MAY 18, 2026 REGULAR MEETING

A. Coastal Development Permit No. 23-073, Variance No. 25-019, Site Plan Review No. 23-035, and Minor Modification No. 24-005 – An application for the construction of a single-family residence and associated development (Continued from March 16, 2026)

Location: 32832 Pacific Coast Highway, within the appealable coastal zone
APN: 4473-017-023
Owner: Sun is Shining, LLC
Case Planner: Senior Planner Achis, AICP, 456-2489, ext. 247

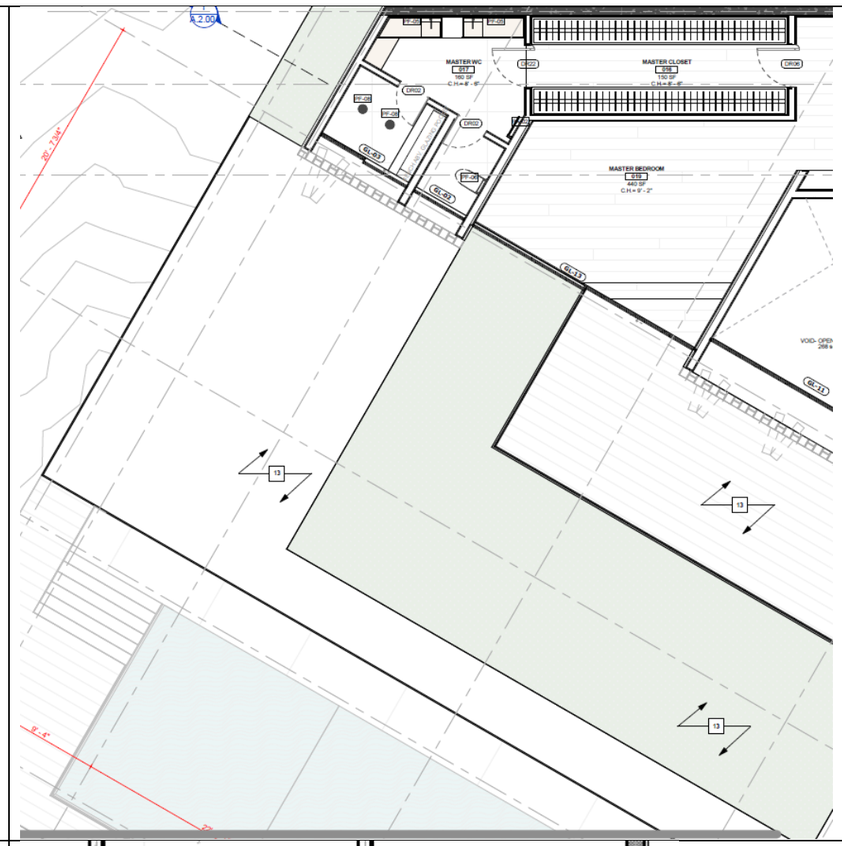
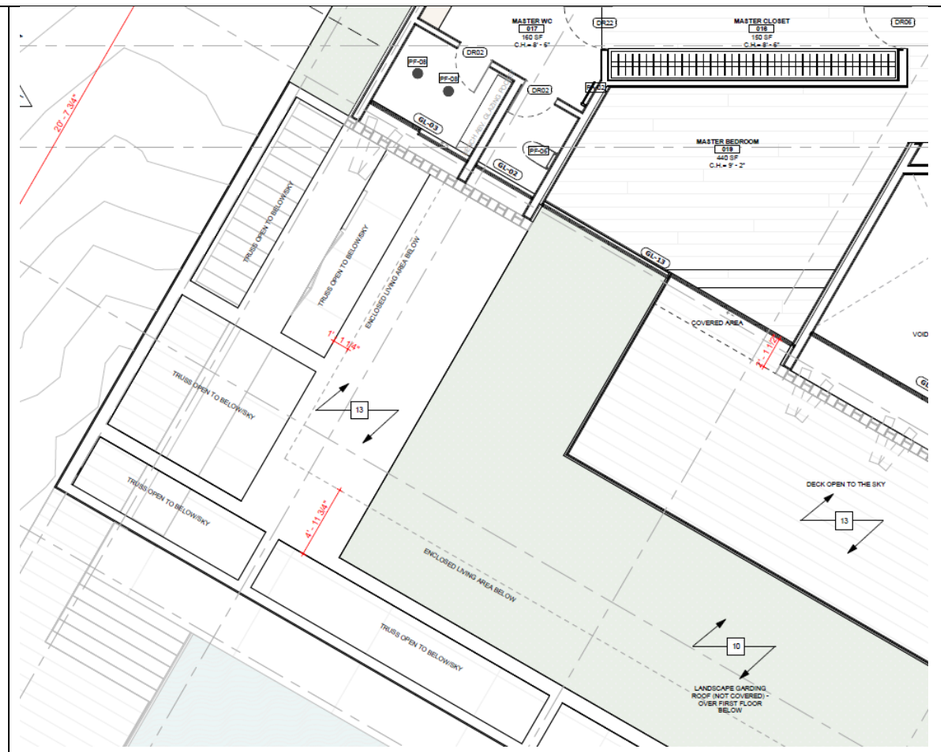
A.1.100			Dimensioned covered area over sink, which is required by EH, and over prep area at 2'-6". Area over the walkway is open truss/pergola- see roof plan.

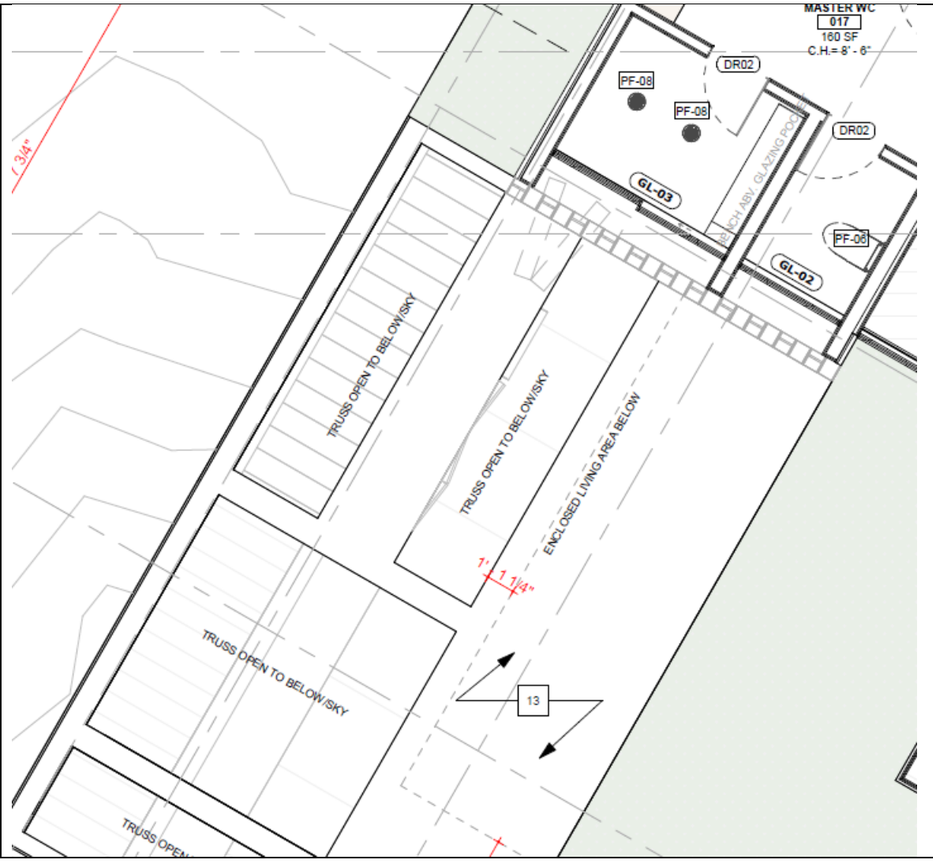
A.1.101			Floor plans have been updated to clarify the proposed open truss/pergola design over exterior areas, the enclosed living area below, and to clearly delineate dimensions of covered areas and areas open to the sky in response to questions regarding conformance with the 6-foot covered area threshold.
A.1.101

A.1.101			
A.1.101			Reduced balcony reflects the reduction of the SFR on the east side. Covered balcony identified as such and dimensioned.

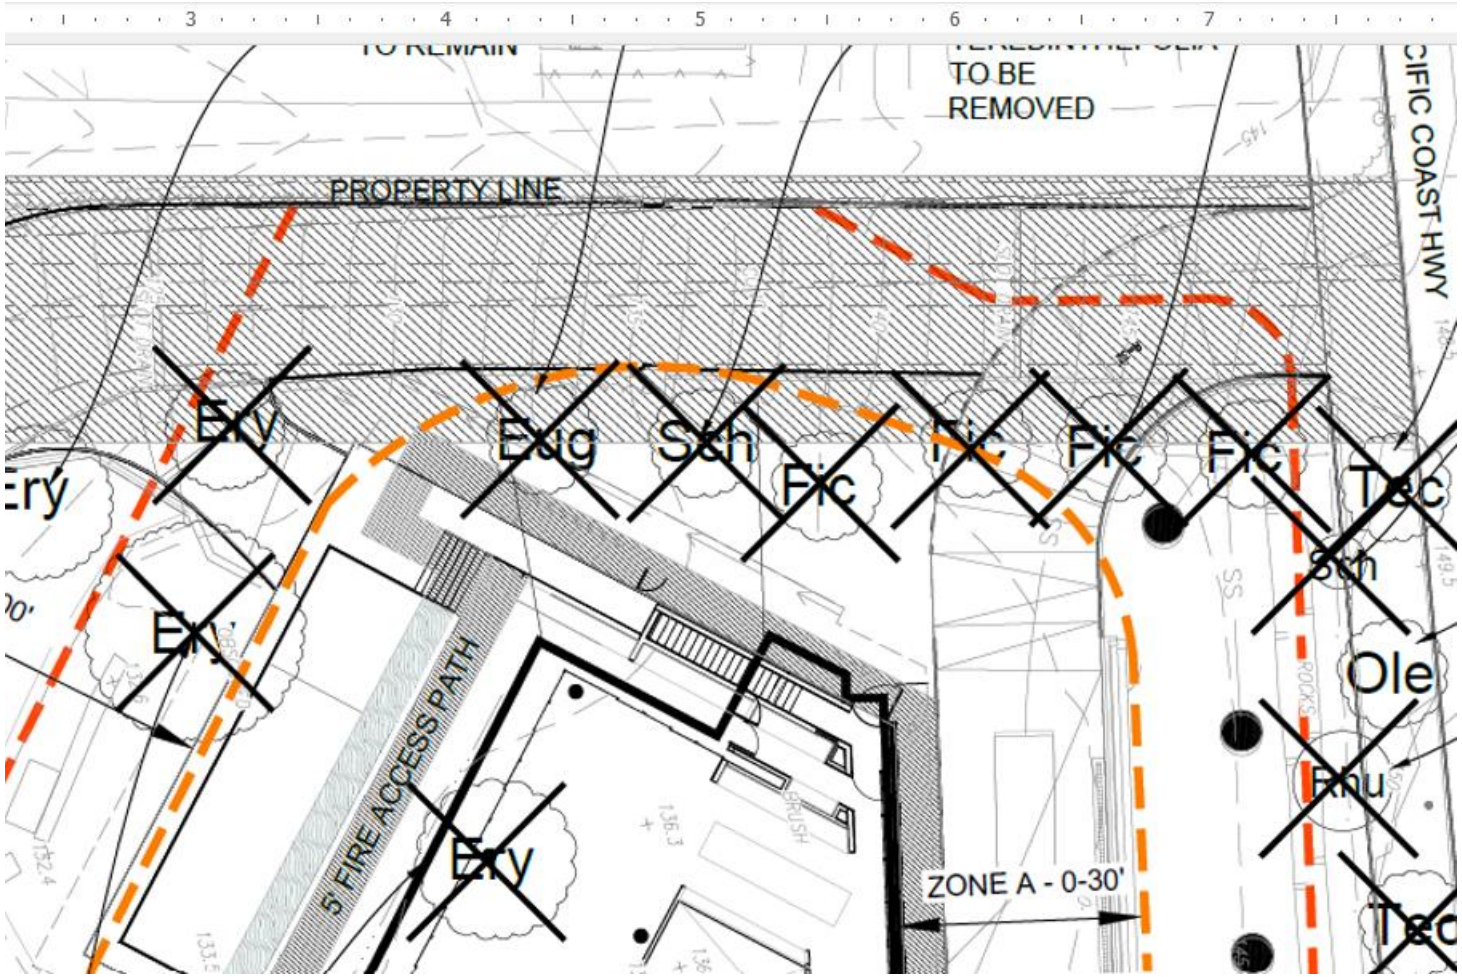
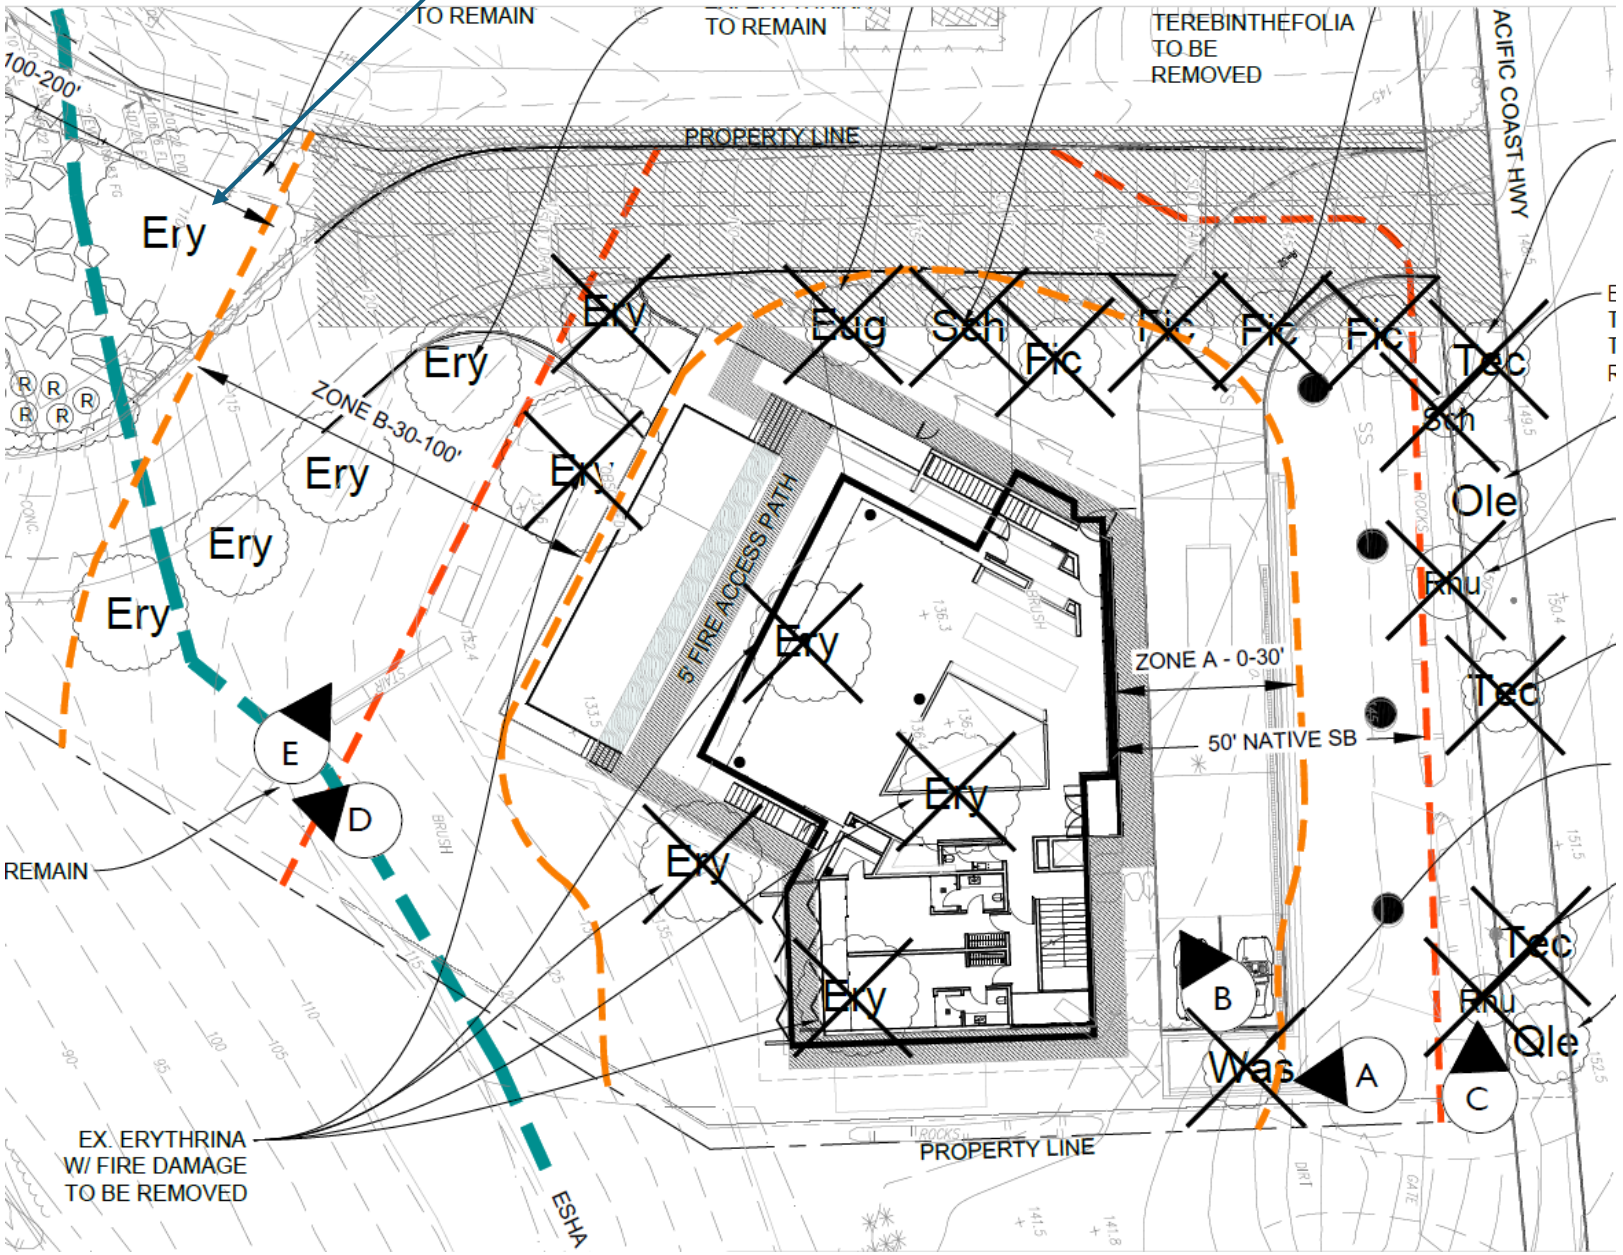
All trees within the proposed view corridor that extend above road grade are proposed to be removed in order to open and preserve ocean views. The site topography drops significantly from PCH, which inherently enhances view opportunities as the parcel descends.

The tree at the bottom of the driveway referenced by the Commission is located on the subject parcel; however, it was installed by the neighboring property owner as part of their entry landscaping. In an effort to maintain good neighbor relations, the owner has sought to retain this tree unless its removal is necessary to achieve compliance.Because the tree is located largely below road grade and is regularly maintained, it does not create a material obstruction to ocean views. To further address this, the owner has proposed a wider view corridor than otherwise required by Code, thereby offsetting the retention of this tree.

Proposed view Corridor

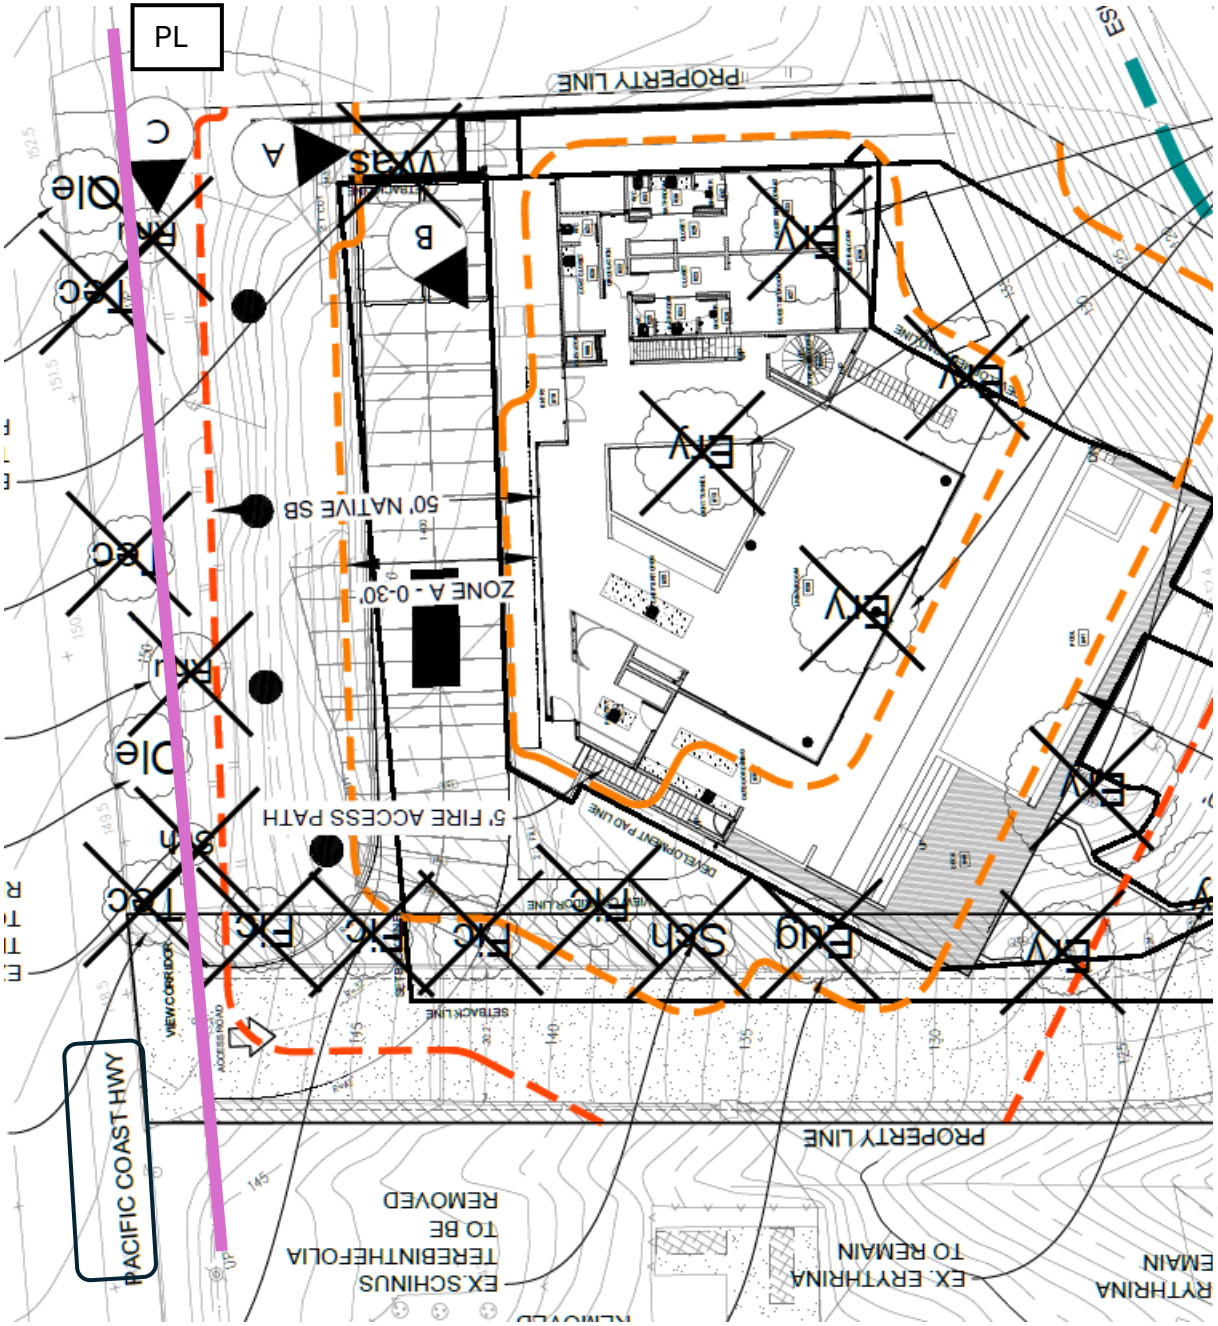
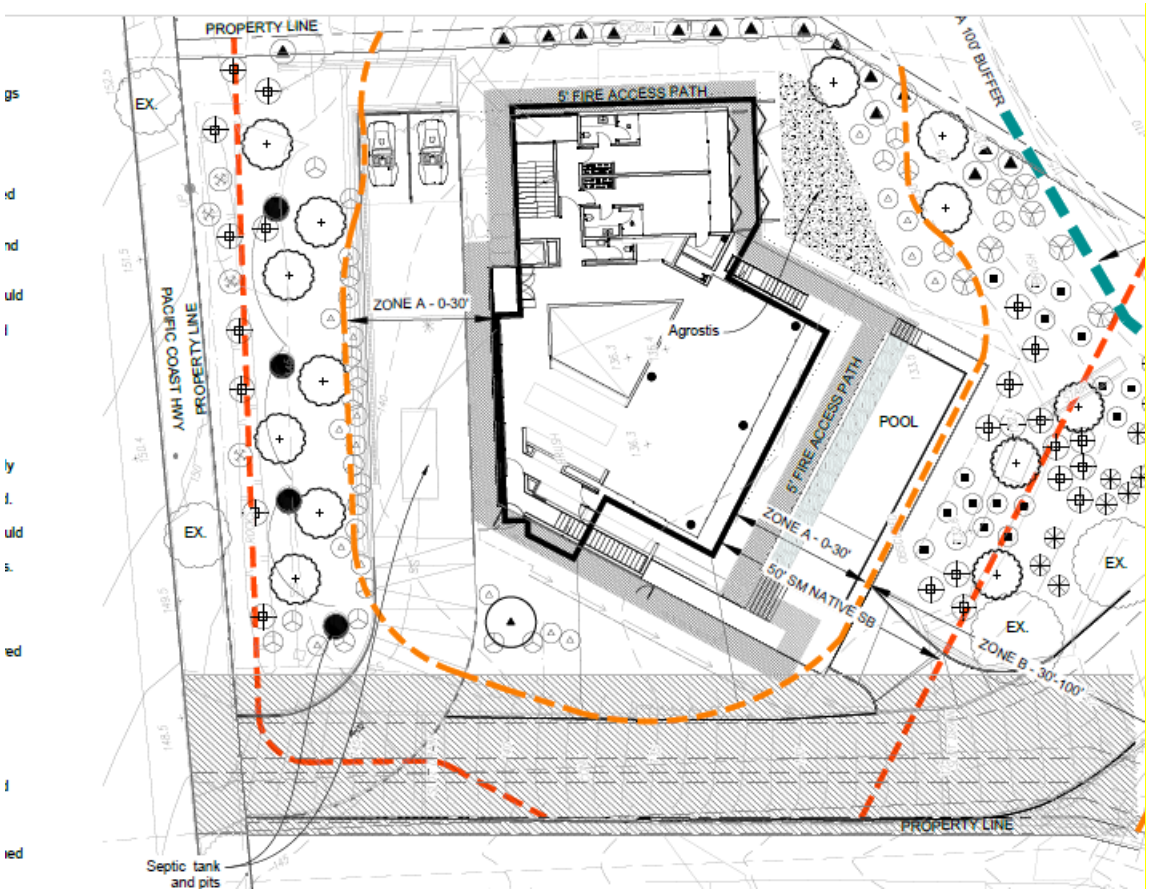
Additionally, the project proposes a more expansive view corridor along the ocean-facing portion of the parcel to meet the intent of the view corridor provisions, even though this approach exceeds the strict language of the Code. While the Code contemplates corridors running parallel to property lines, the proposed design extends the line of sight along the length of the parcel to maximize available views.

It is also important to note that the subject parcel does not front the ocean. There are multiple intervening properties between the site and the coastline, all of which are heavily landscaped and outside the owner's control. The proposed view corridor is therefore located along the western portion of the property—consistent with prior Coastal Commission approval—as this area provides the most meaningful and feasible view opportunities. The opposite side of the parcel is constrained by both the site geometry and intervening development, limiting its effectiveness as a view corridor.

The vegetation on the left side of the purple line (PL) is off-site and within the Caltrans ROW and subject to Caltrans authorization. The owner is proposing to remove the Tecomaria shrubs, which is a fast growing screening shrub. Two fruitless olive trees on either side of the property are proposed to remain.
